SASSARIXA SWAMP MITIGATION PLAN

Johnston County, NC
NCDEQ Contract No. 7425
DMS ID No. 100040

RE: Sassarixa Swamp Mitigation Site – NCIRT Comments during 30-day Mitigation Plan Review
Sassarixa Swamp Mitigation Site (USACE AID# SAW-2018-00432, NCDMS # 100040)
Neuse 03020201, Johnston County, NC

Figure 8. Proposed Monitoring Map
 Sassarixa Swamp Mitigation Site
 Neuse River Basin 03020201

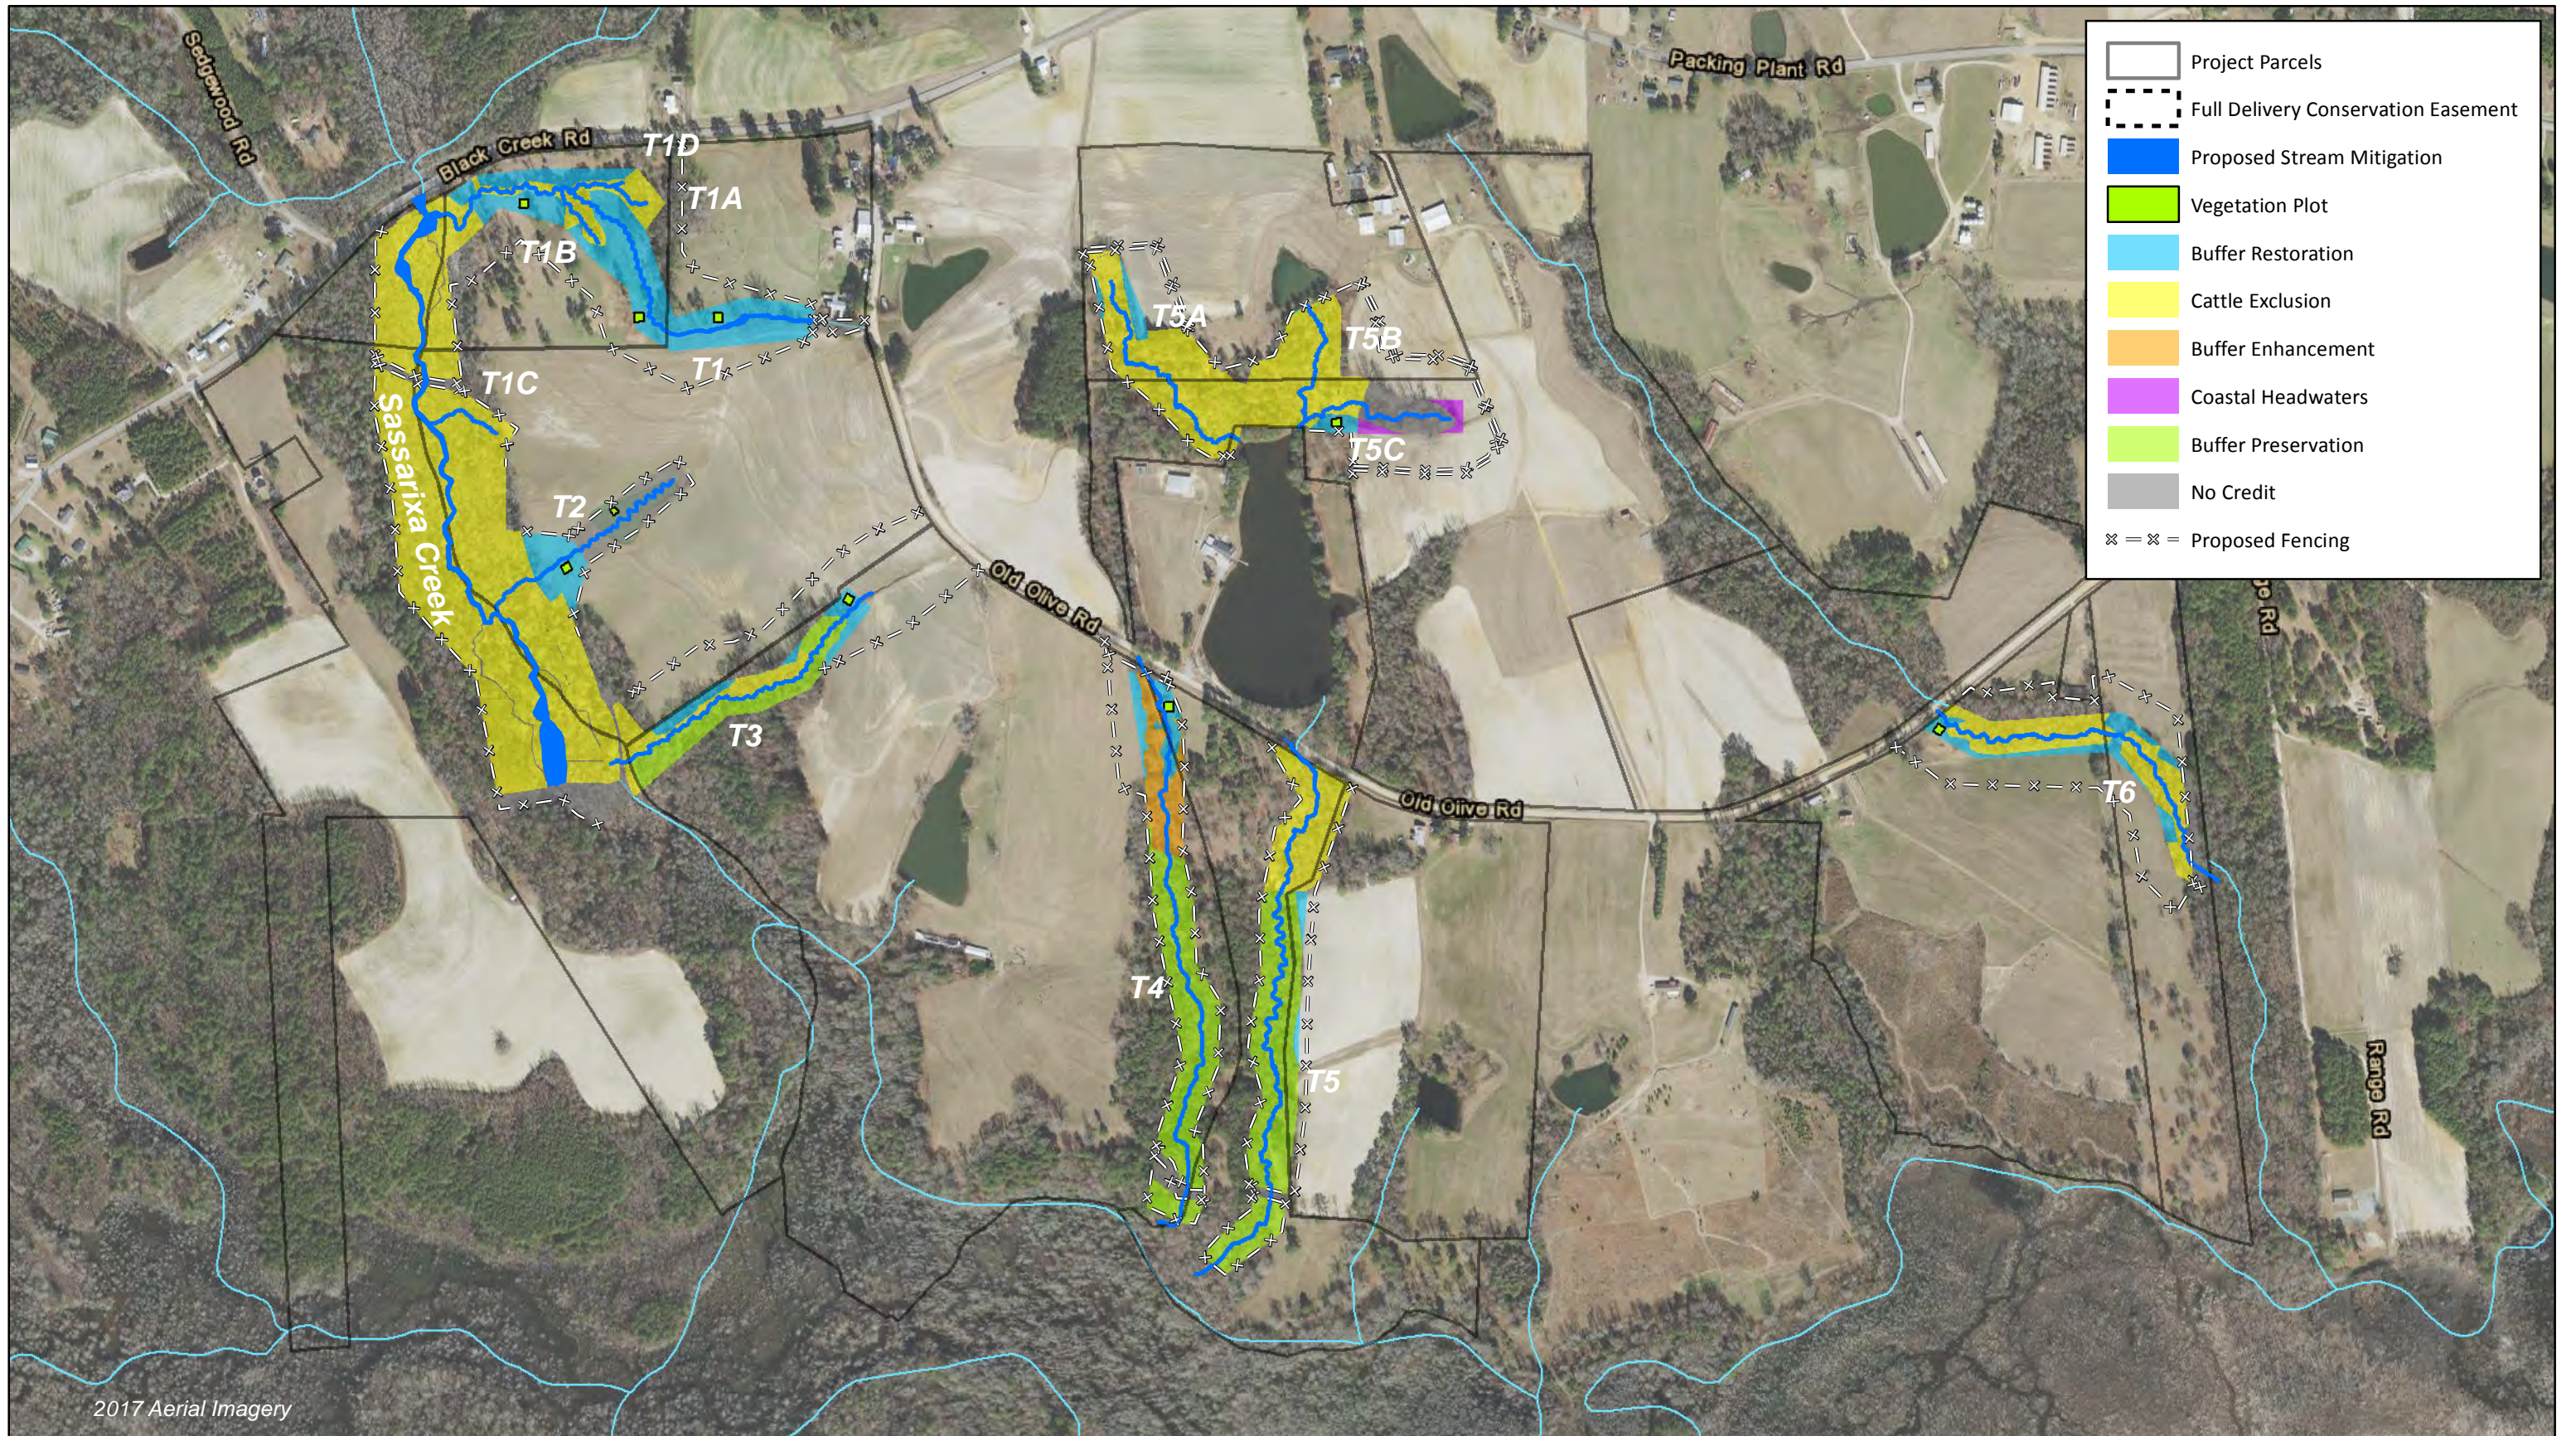
16. Figure 8 –

Figure 8 has been updated according to above changes.

Figure 6. Existing Conditions Map
 Sassariixa Swamp Mitigation Site
 Neuse River Basin 03020201

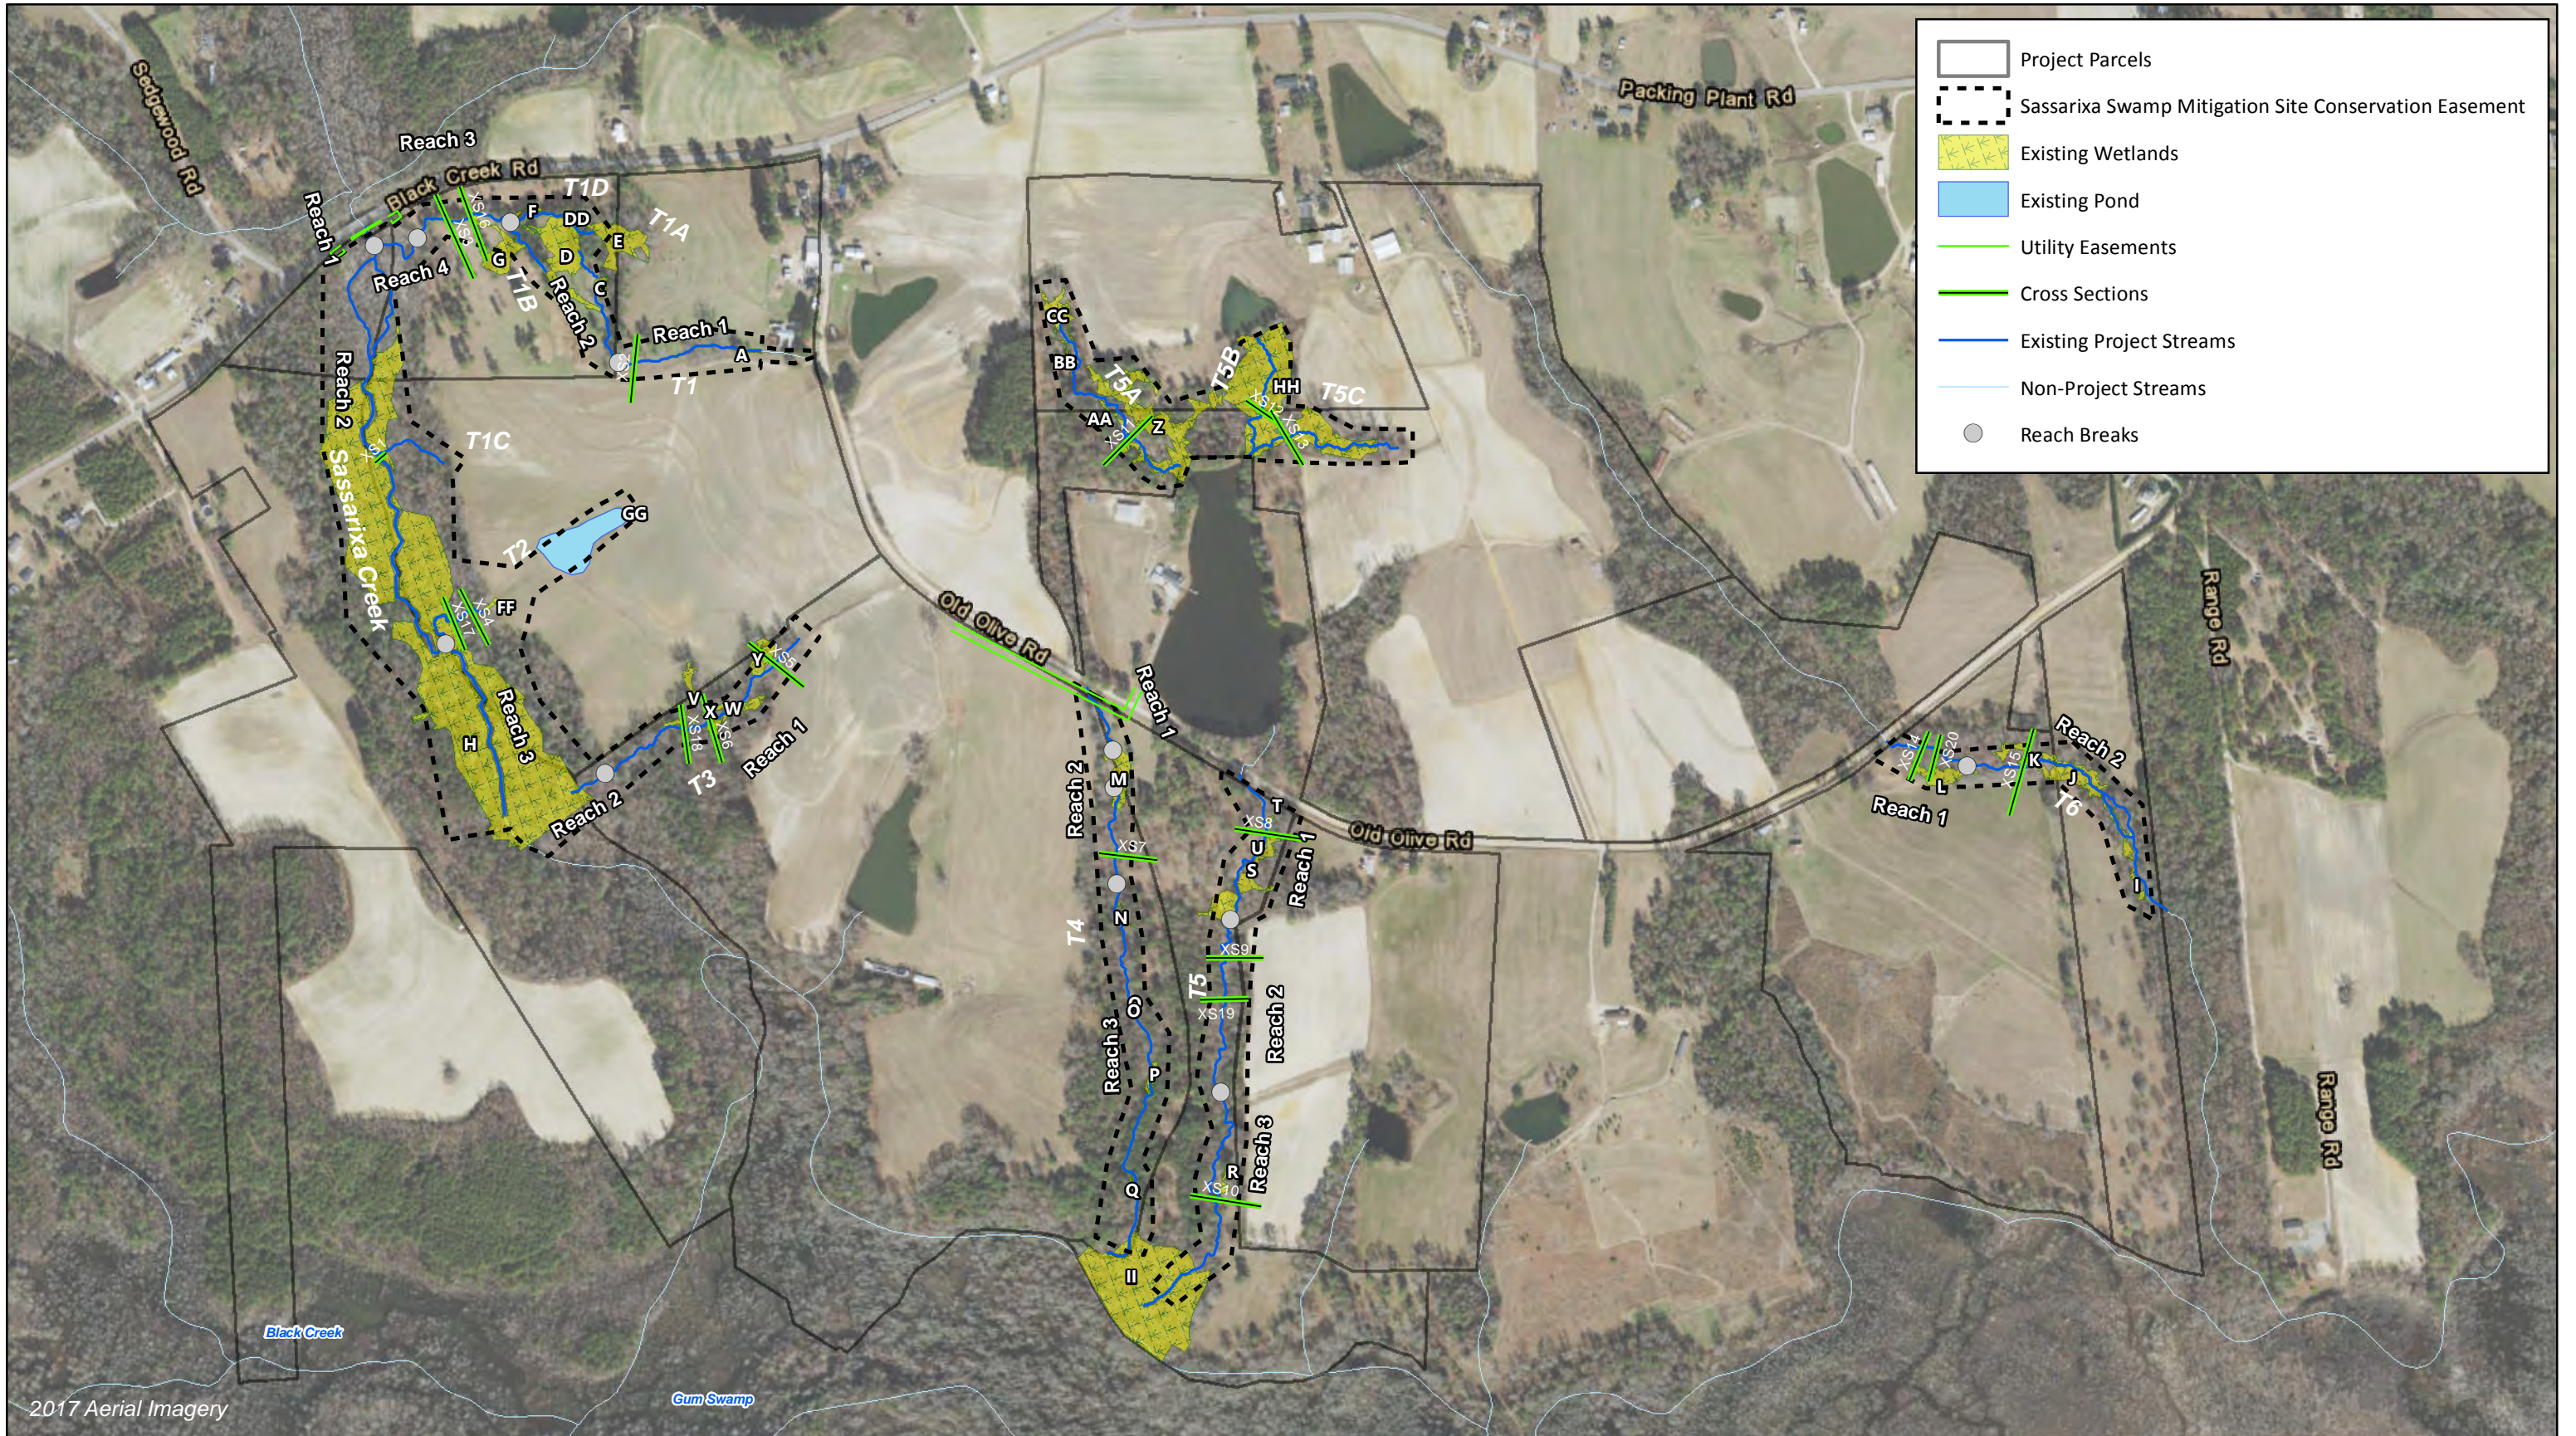
3. There appears to be considerable wetland acreage on site (Figure 6). Table 6 states there are 13.034 acres of wetland on the site, which represents approximately 22% of the conservation easement/project area. We are a little surprised there wasn't more discussion of what the proposed site will do to enhance/restore these wetlands.

Figure 11. Monitoring Components Map
Sassarixa Swamp Mitigation Site
Neuse River Basin 03020201

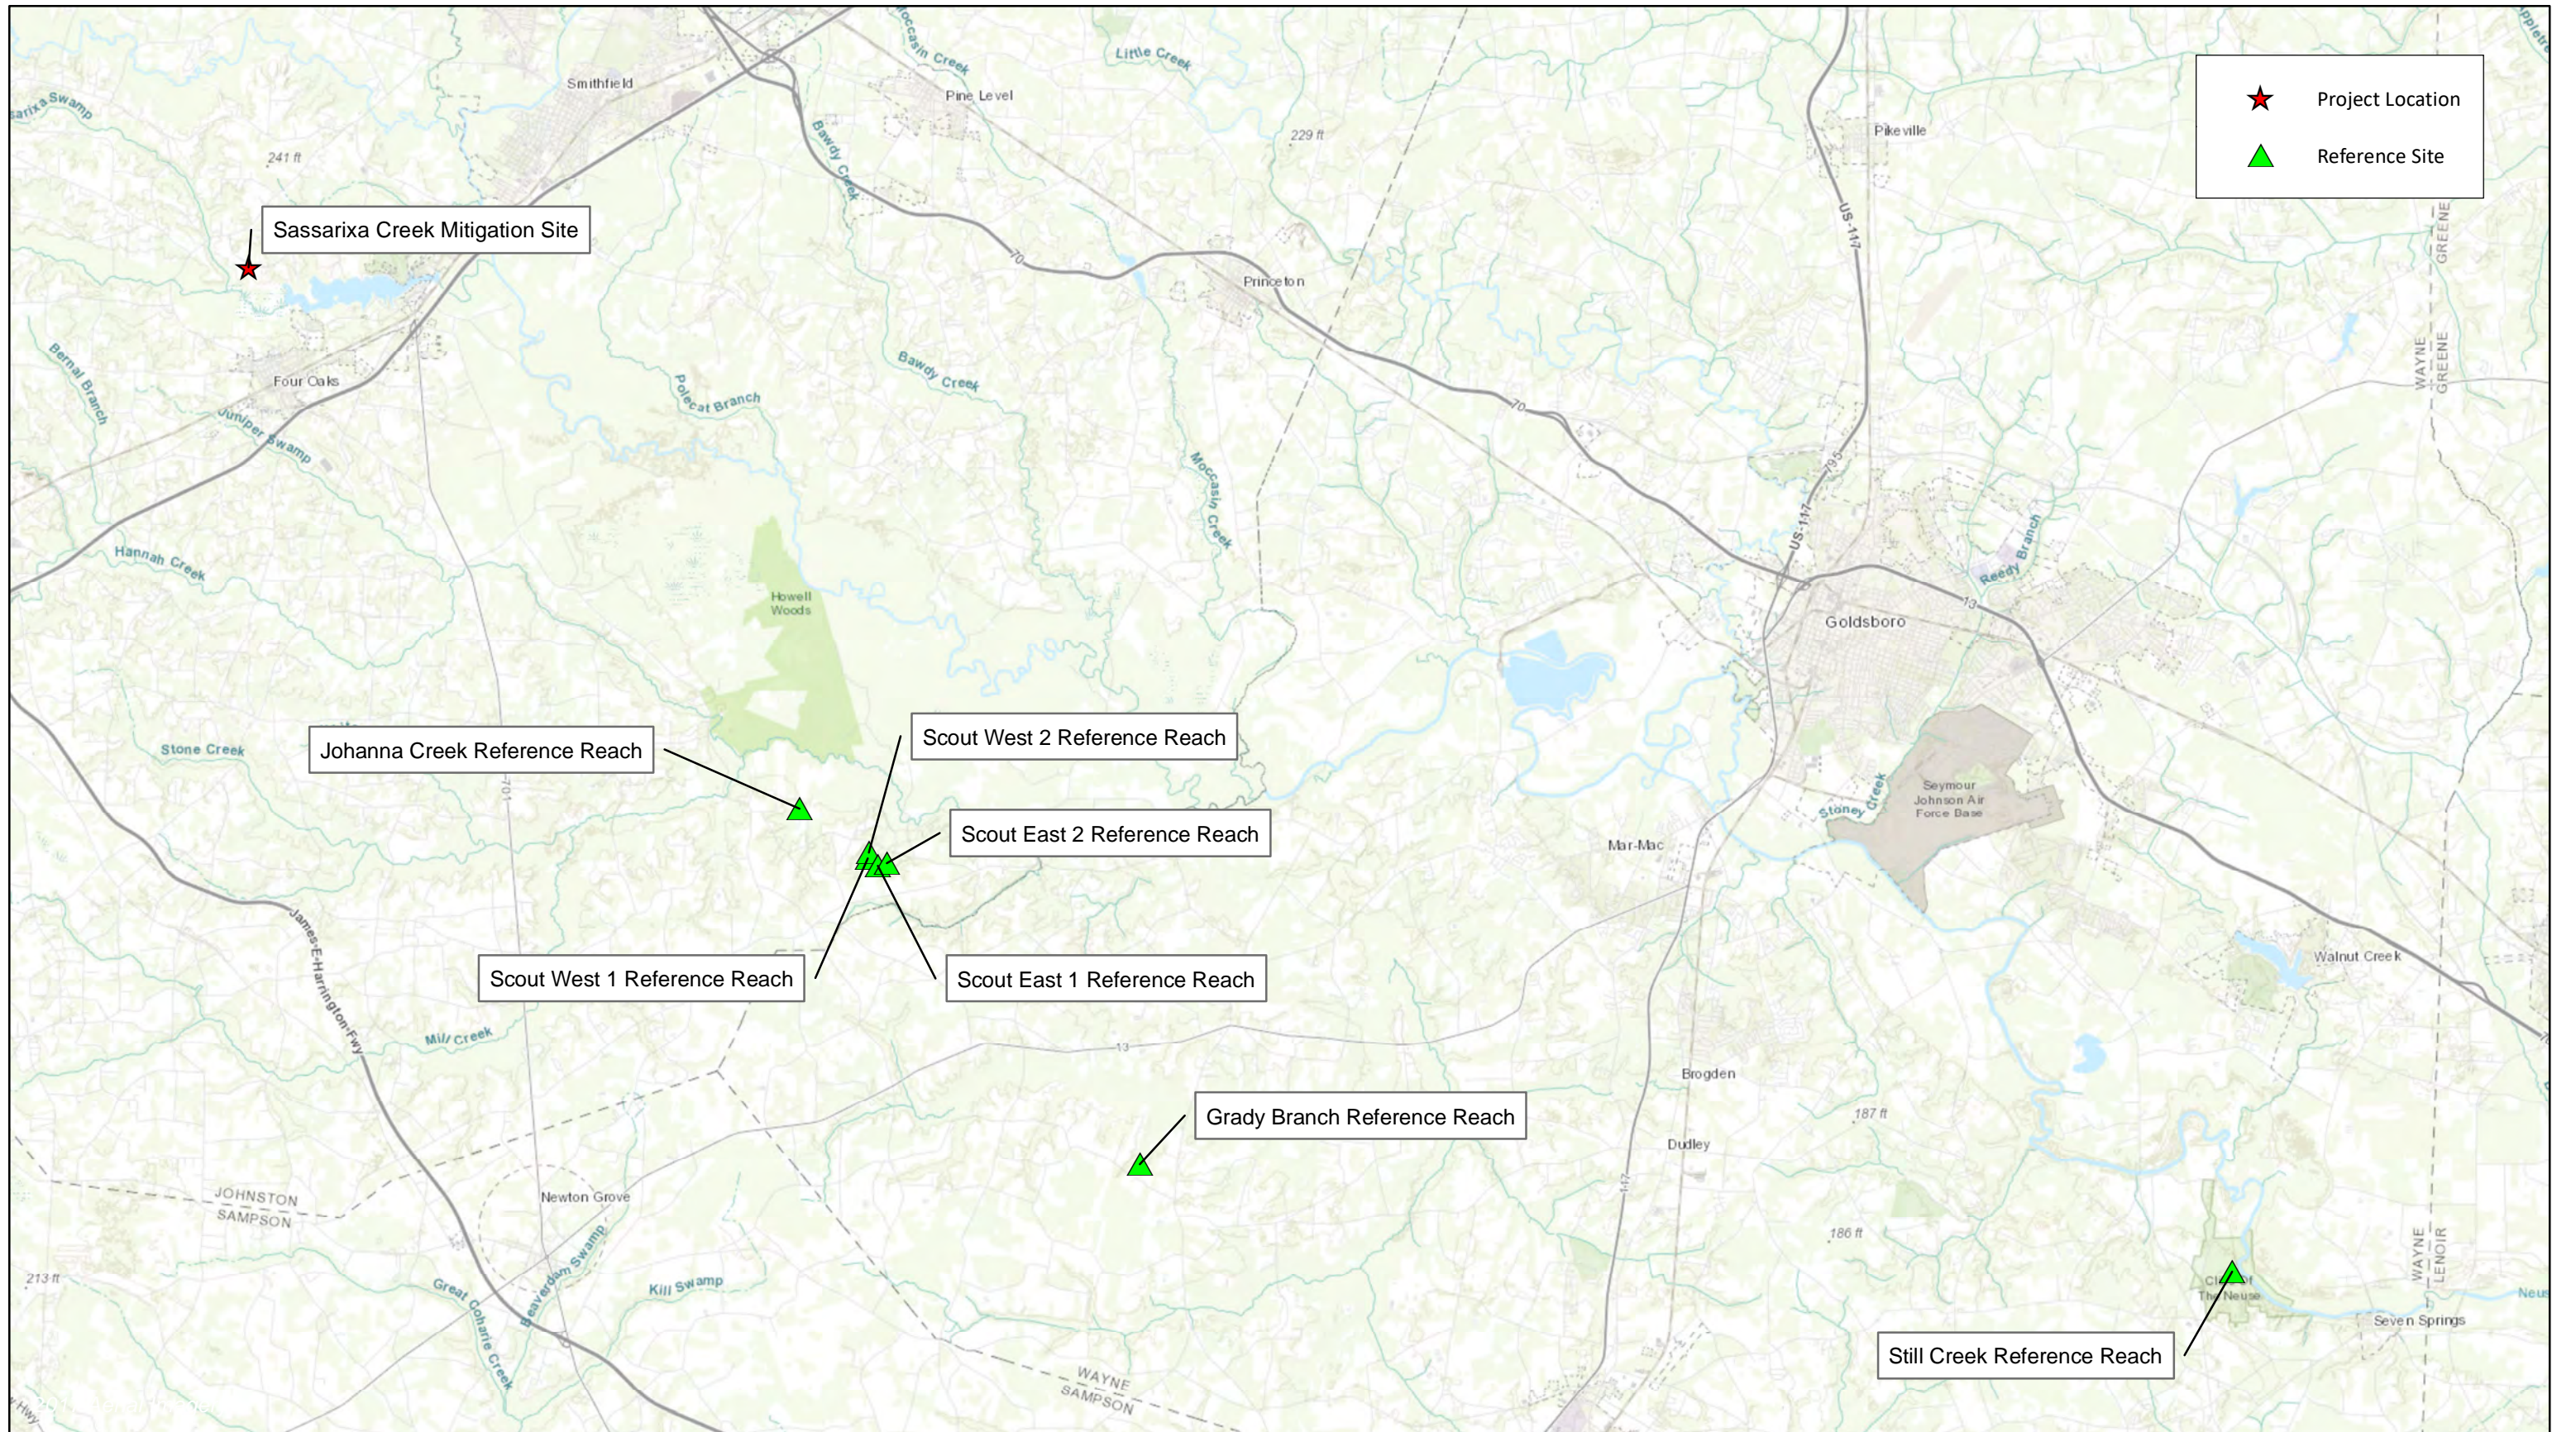
6. Figure 11 – Monitoring Component Map – The flow gauge for T2 will need to be moved down to at least mid-reach (out of the relic pond bed). DWR requires an additional flow gauge on reach

T3 at station 402+30 (design sheet 1.31). In addition, depending on the answer to #4, DWR may require another flow gauge on T4R3.

Flow gauges on T2 and T3 are added to Figure 11 as described above.
